**Paramount Resources Ltd.**

**Significant Discovery Licence 8, 2D Geophysical Program**

**Environmental Assessment EA0506-007**

**Round 2 Information Request Responses  
IR0506-007-15 to IR0506-007-23**

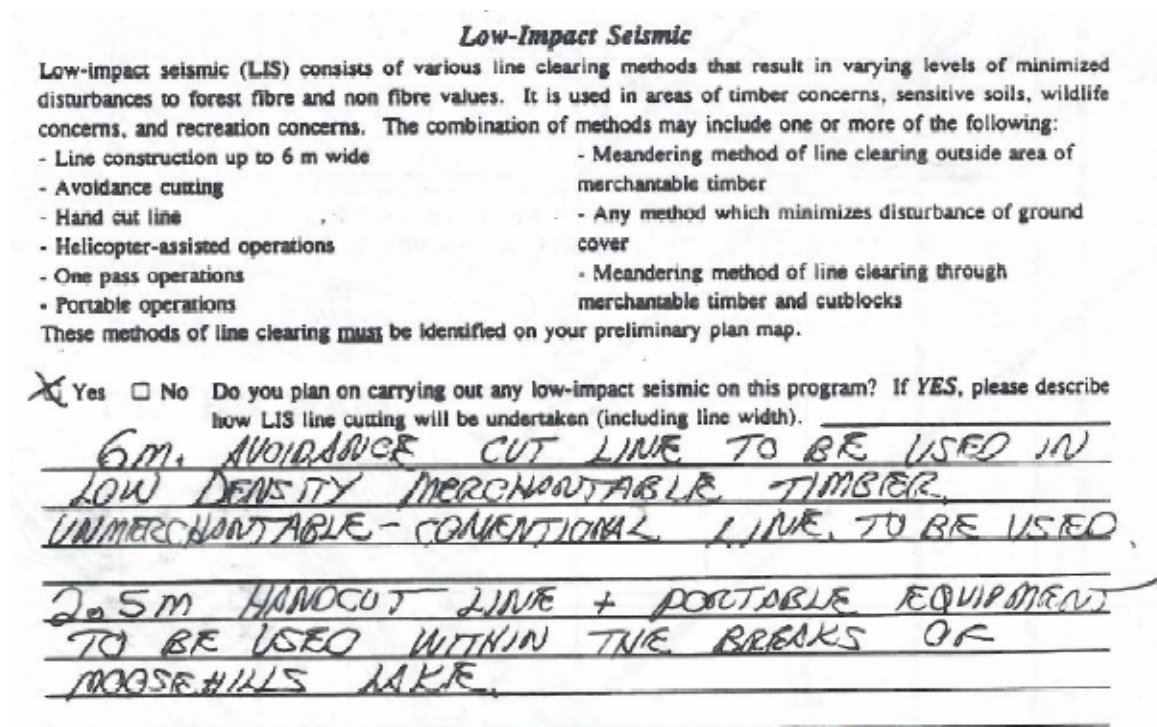
**Preamble:** Paramount uses the phrase “low impact seismic” or “LIS” in referring to its seismic activities but does not explain the reference for the phrase.

**Request:** Please provide the origin, definition and details of “low-impact seismic” as that phrase is used by Paramount. Provide evidence to support Paramount’s response.

**Response:** The precise origin of the phrase “low-impact seismic” is unknown to Paramount. The definition and details of “low-impact seismic” as used by Paramount have their origin in guidelines established by Alberta Environmental Protection, Forest Management Division, Client and Field Services in 1994. The Geophysical Application Information form, which was filled out for all seismic exploration programs, contained a section and definition on Low-Impact Seismic. An example is shown below:
